PROPERTY ADDRESS: 12439 Barnard Way

RE: 12439 Barnard Way
Percolation Certification Plan

The following comments apply to the plan prepared by Landesign Inc, Engineers, Surveyors, and Planners. Applicant is advised to revise and resubmit.

BAT SITE PLAN
P# 544569

See As-Built Drawing
On Separate Sheet

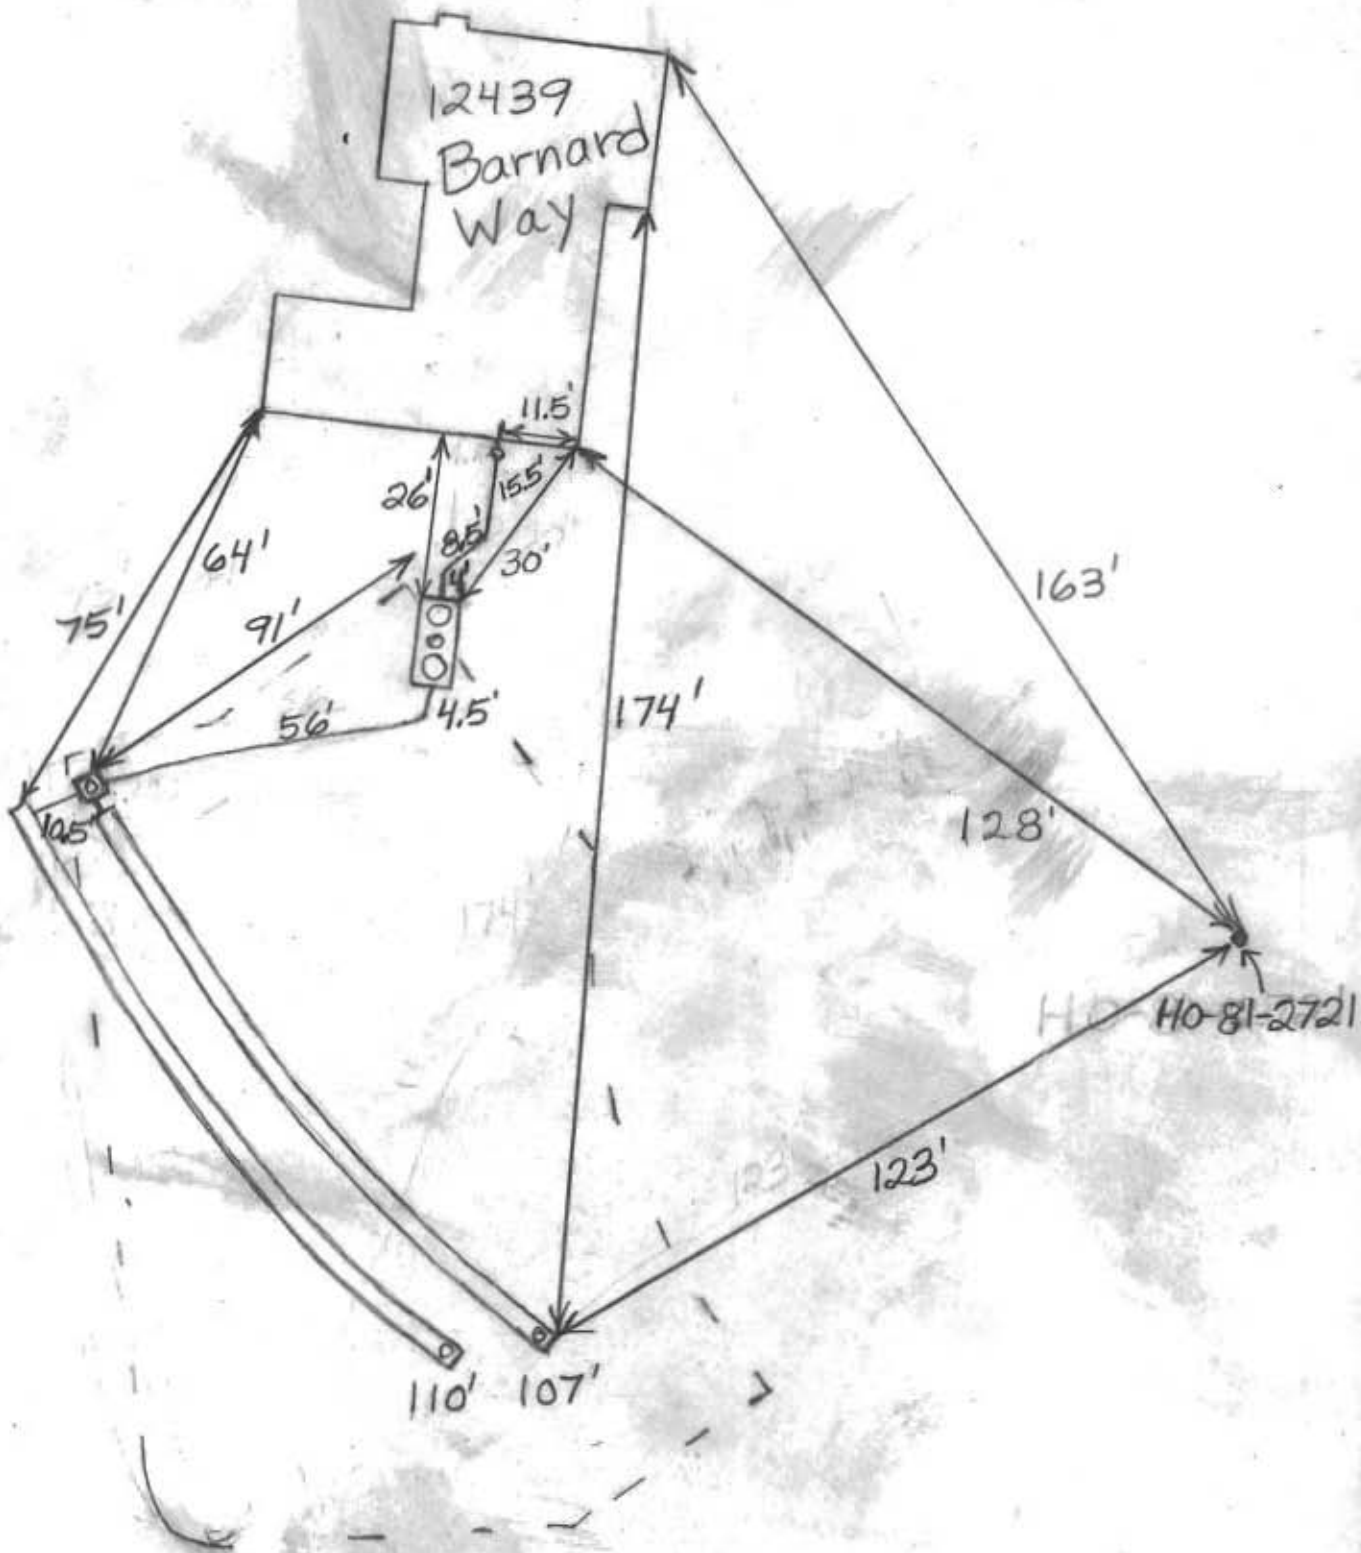
7/7/2014 Layout done, add to trenches so that they are
at least 105' long. Install tank per plan. (BB)

7/7/2014 (PM) Trenches full. Must layout new system. (BB)

7/8/2014 (PM) Tank and dist. box set and plumbed.
Wrong tank installed. Need the E100 model. The E60
was installed. Will take about three weeks for the E100
to be made. (BB) 7/9/2014 Trenches finished. (BB)

8/1/2014 Ecopod 100 installed. Still need certification
from Ecopod representative. (BB) 9/11/2014 Received
approval from Ecopod distributor. (BB)

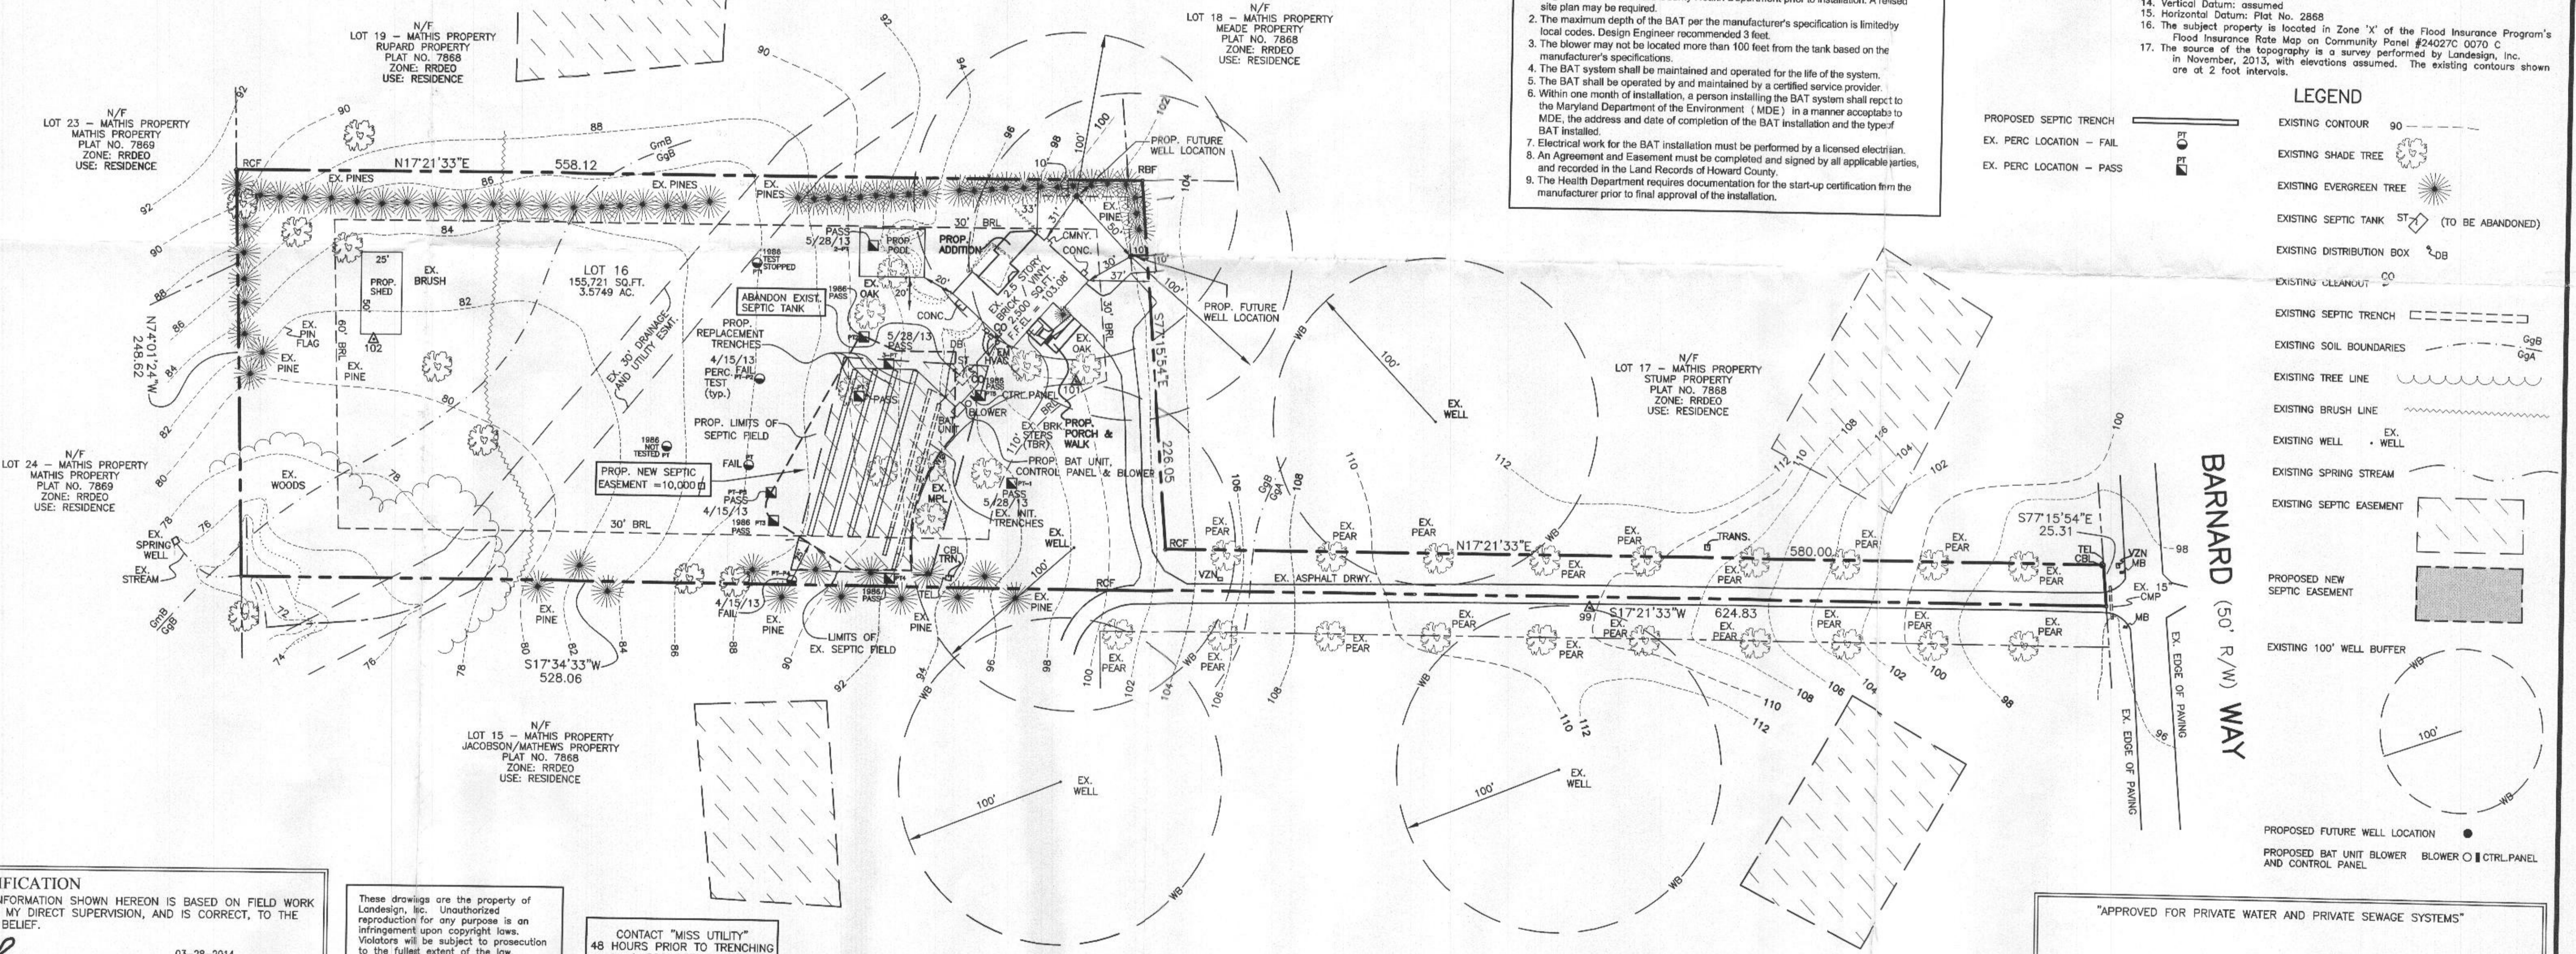
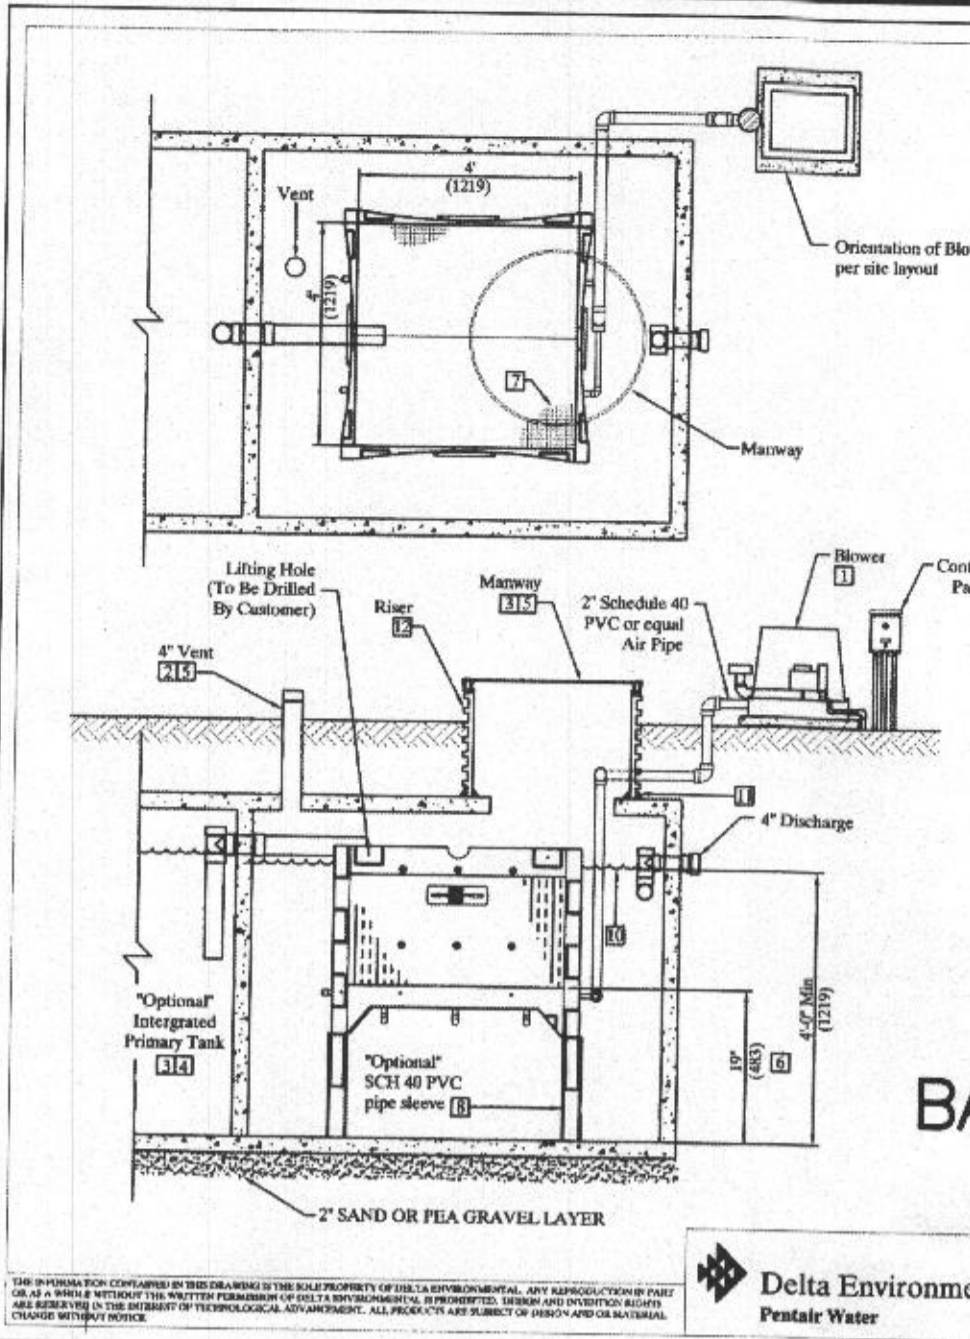
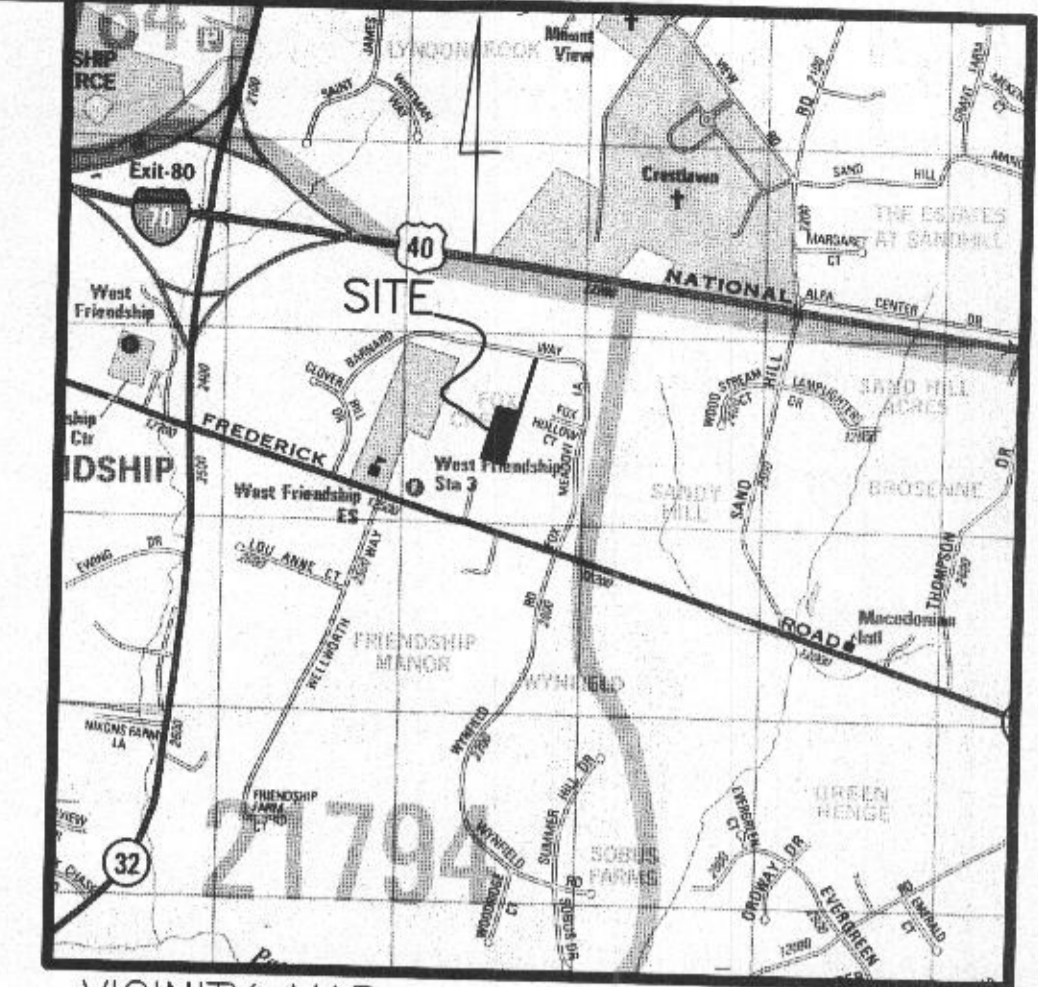
The following comments apply to the plan prepared by Landesign Inc, Engineers, Surveyors, and Planners. **The BAT plan and the Percolation Certification Plan must be separate submissions.** Applicant is advised to revise and resubmit.

- ↓ Include the locations of all BAT components on the site plan and label.

- ↓ Septic easement must show new septic area and delineated septic area and must be shown in the legend. The square footage should be 10,000 square feet.
- ↓ Septic area cannot be within 25' of a failed hole. Only show an initial system and 2 reserve areas in septic easement. Highlight new proposed area and place reserve areas within the highlighted area.
- ↓ Please include the general notes, purpose statement, and legend.
- ↓ Remove the 3 note boxes below the utility easement.

BAT Plan OK DB 4-8-14
